North Campus Faculty Housing Phase II  
Project No. FM110407L/986315

**Addendum No. 6**

ADDENDUM NUMBER 6  
to the  
CONSTRUCTION DOCUMENTS

BUILDING 400B: SECTIONS 1

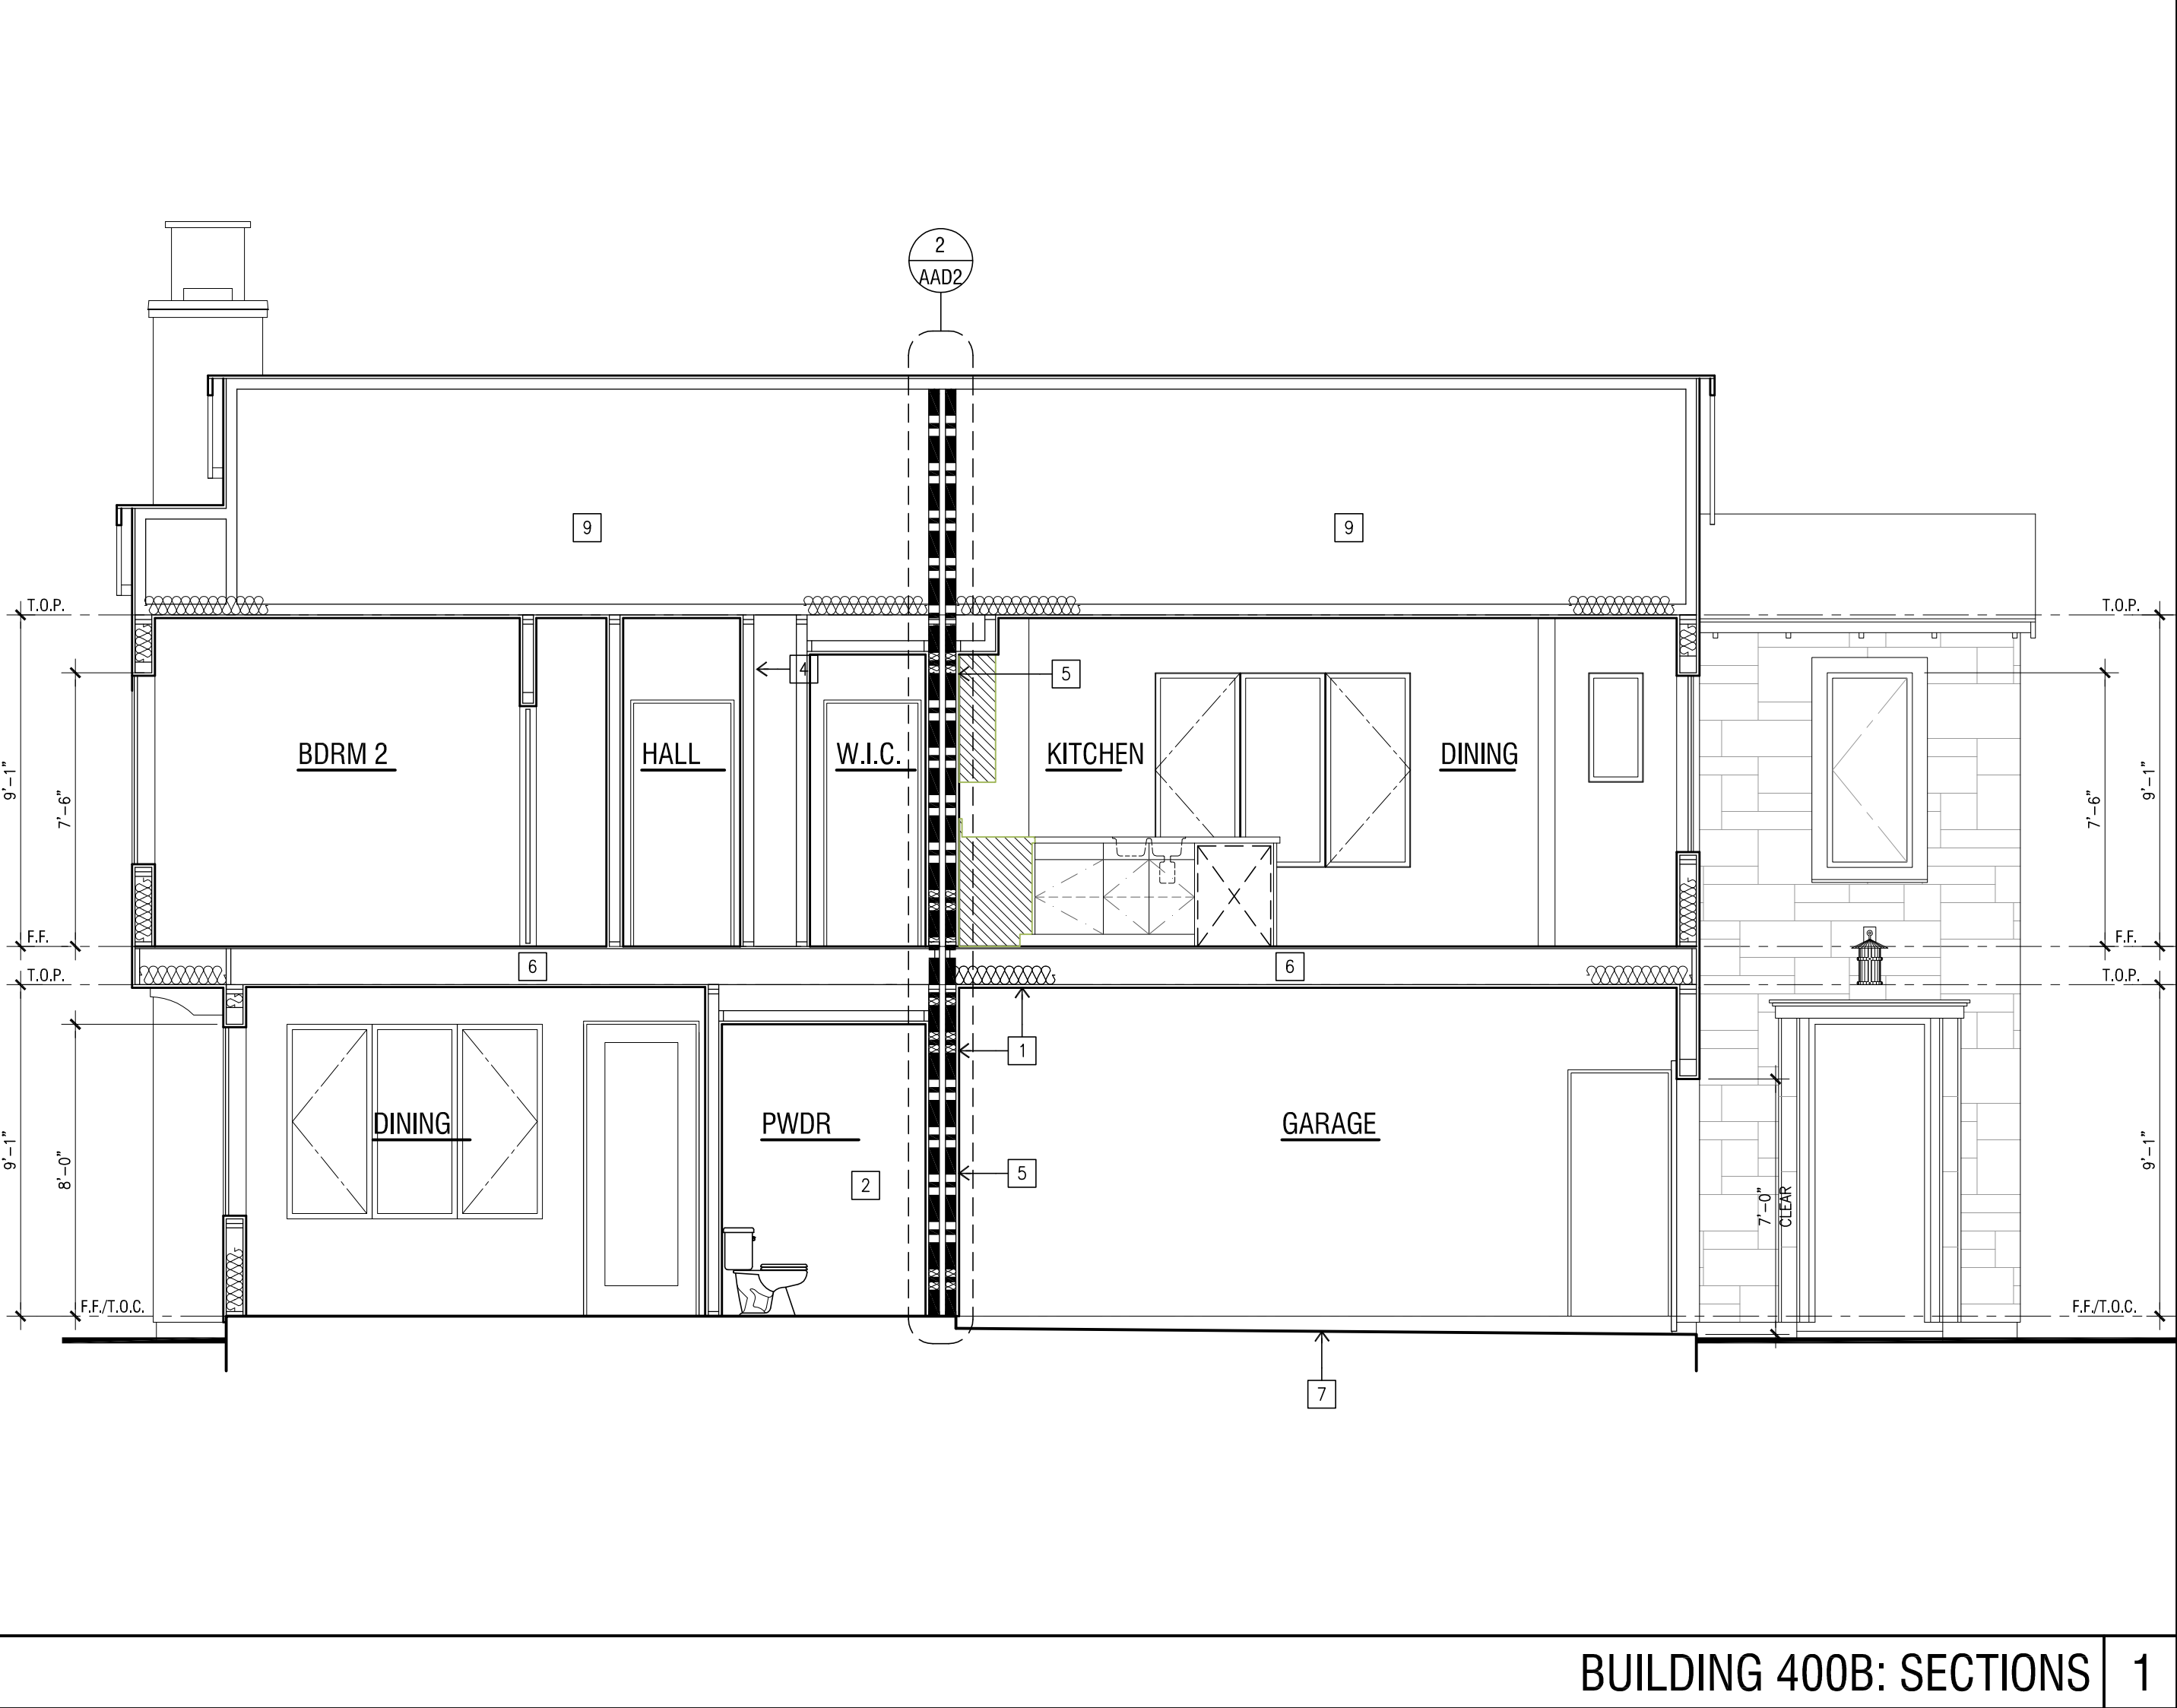
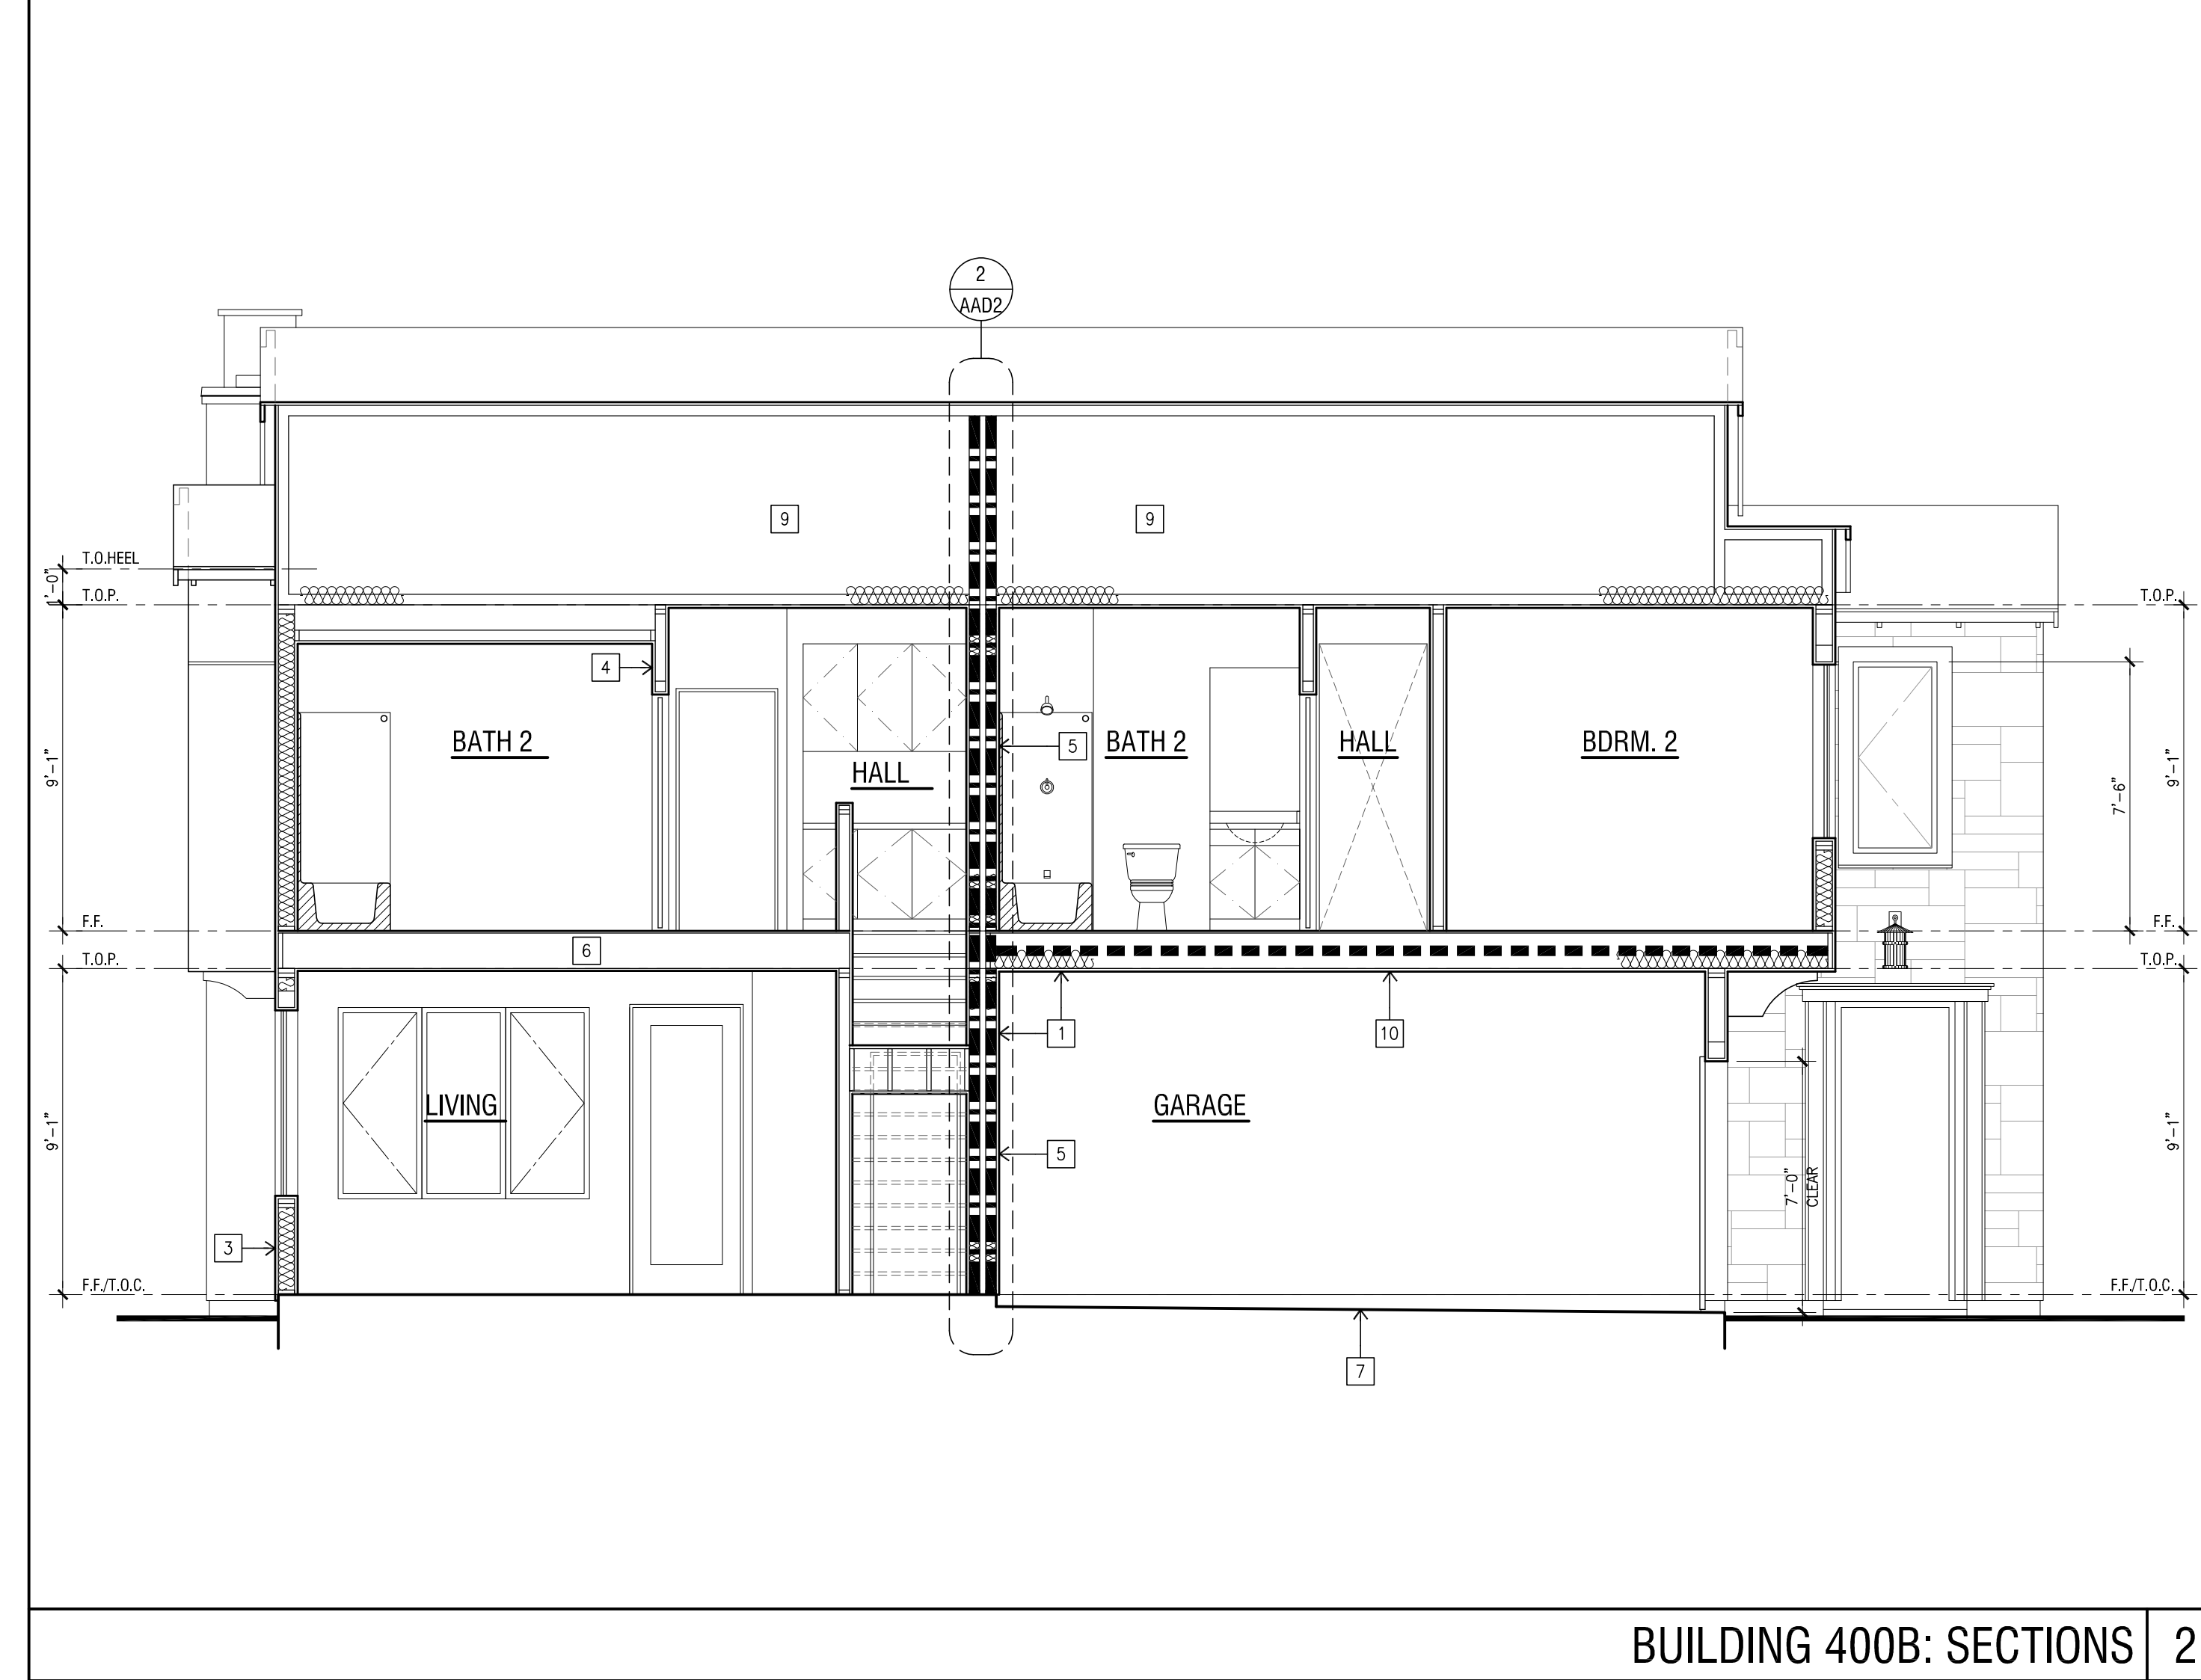
1. **Add** the attached Architect Sketches 1 of 8, dated 9/23/11.  
Sketch 1 of 8 Building 400A: Sections  
Sketch 2 of 8 Building 400B: Sections  
Sketch 3 of 8 Building 500B: Sections  
Sketch 4 of 8 Building 600A: Sections
